Attachment B1

Selected Drawings

PROJECT
2235 BILLYARD 21C
DRAWN SENIOR QA APP'D
MP CM WS

DWG TITLE
LEGEND, DRAWING LIST, SITE MAP
DWG NO REV
DA000 J

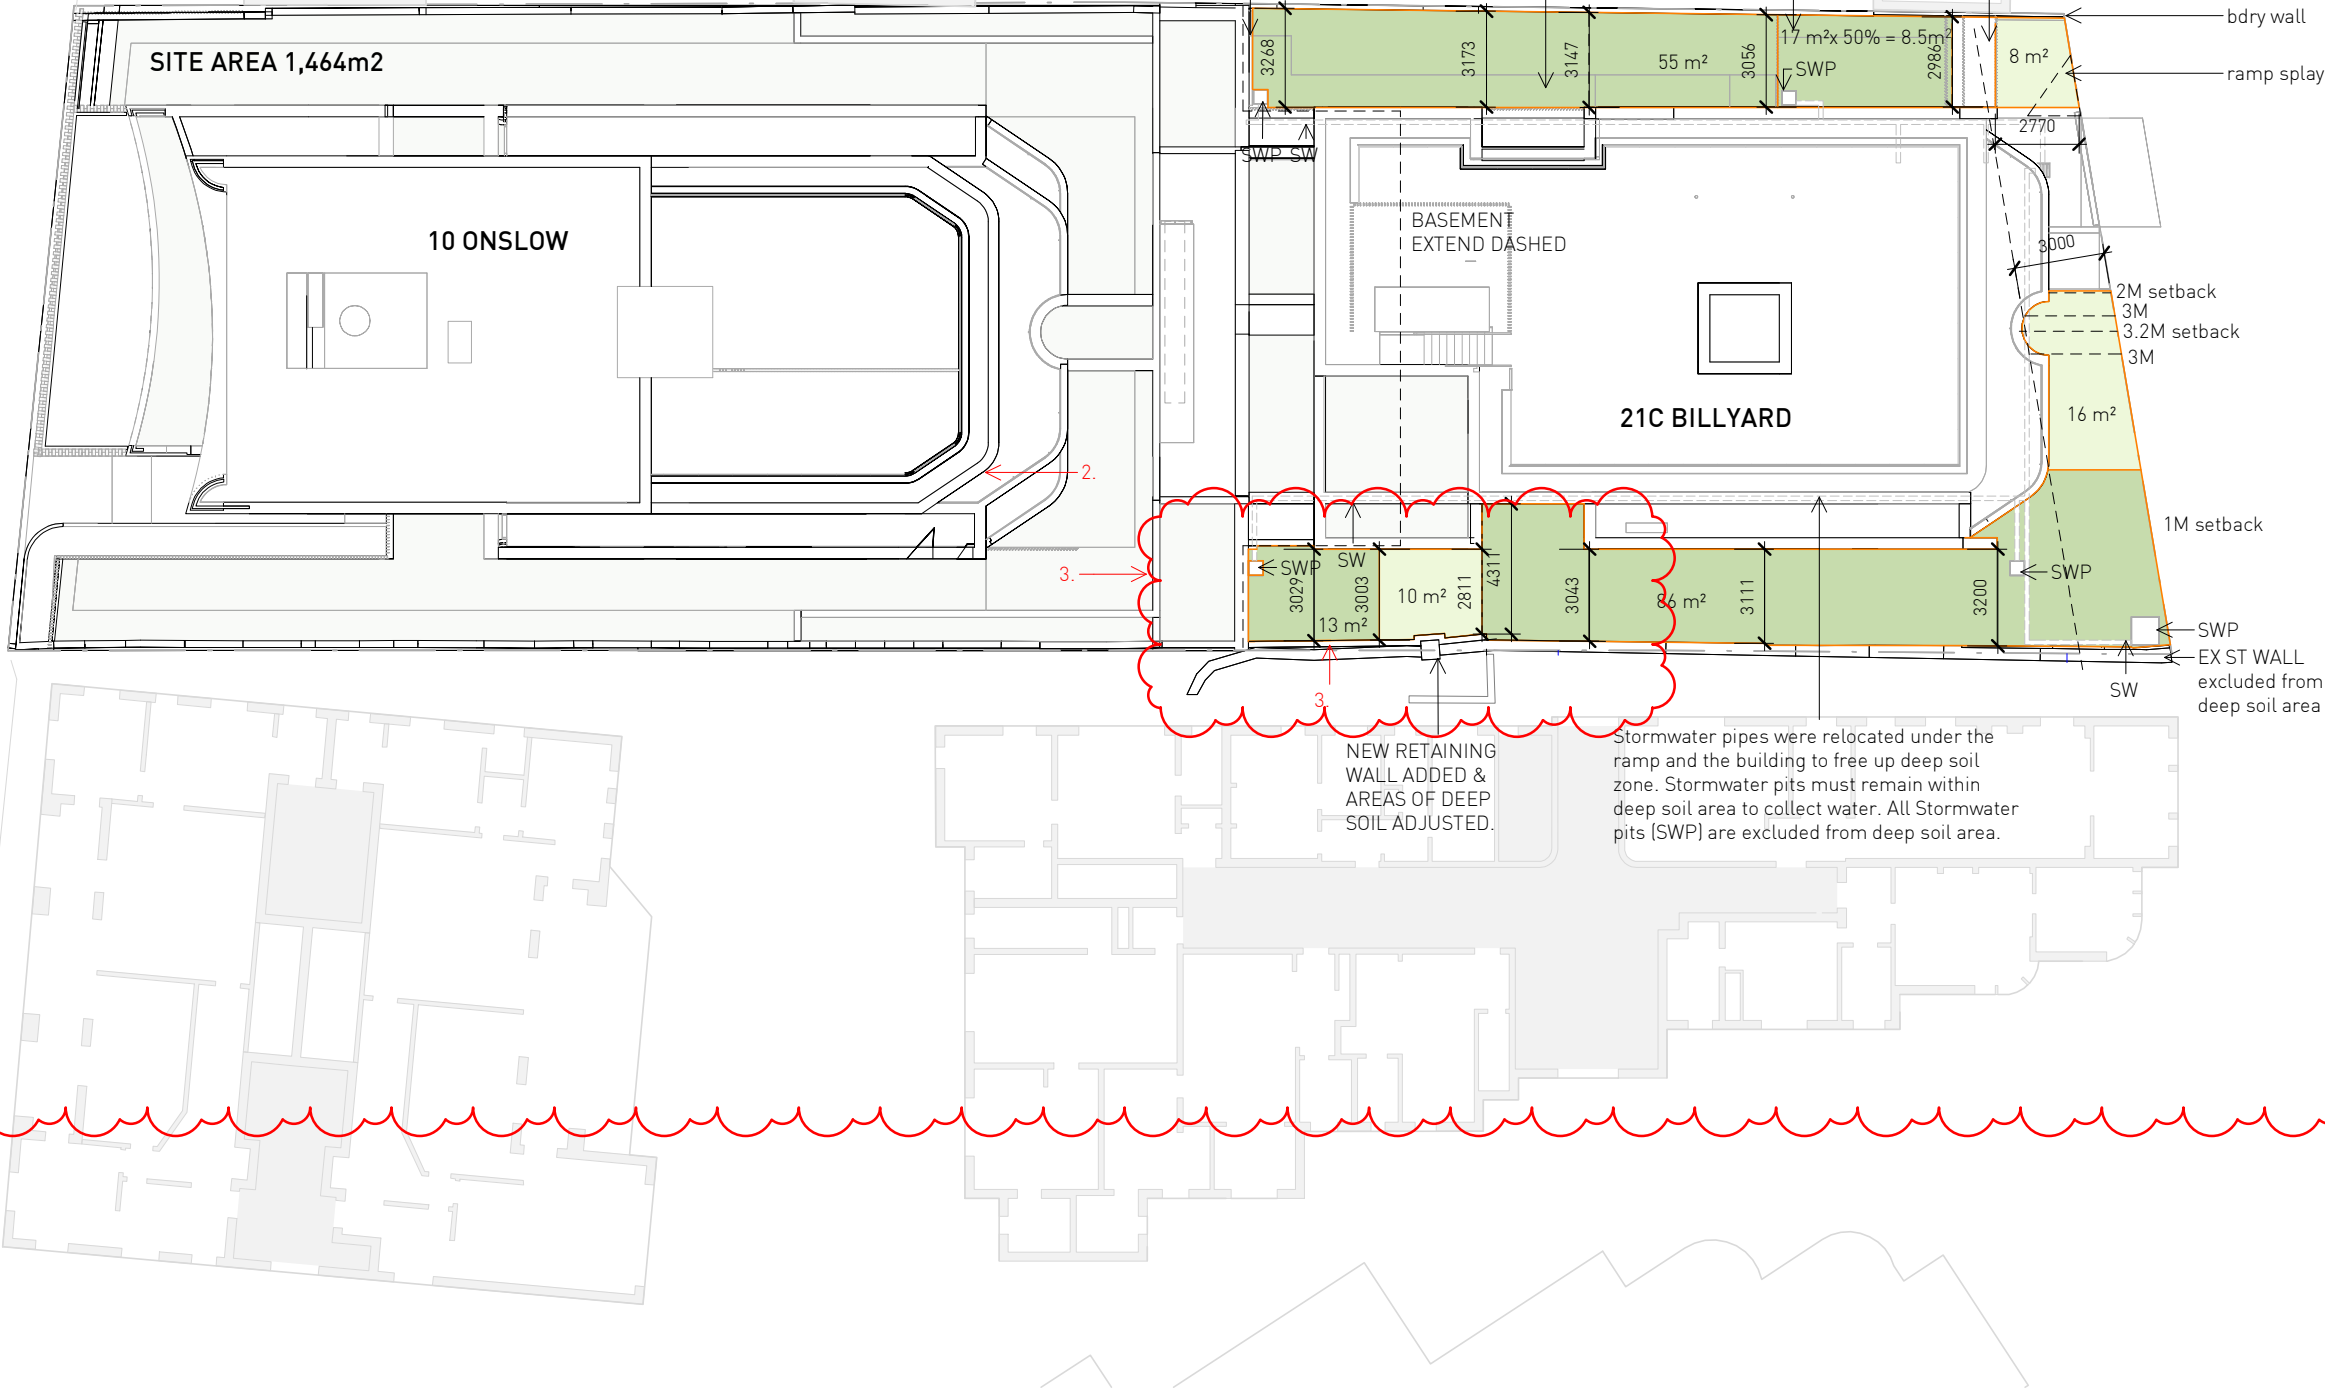
DA ISSUE 07:
2. Top form adjusted for solar
compliancey.

DA ISSUE 08:
3. New retaining wall added and
excluded from Deep Soil area.
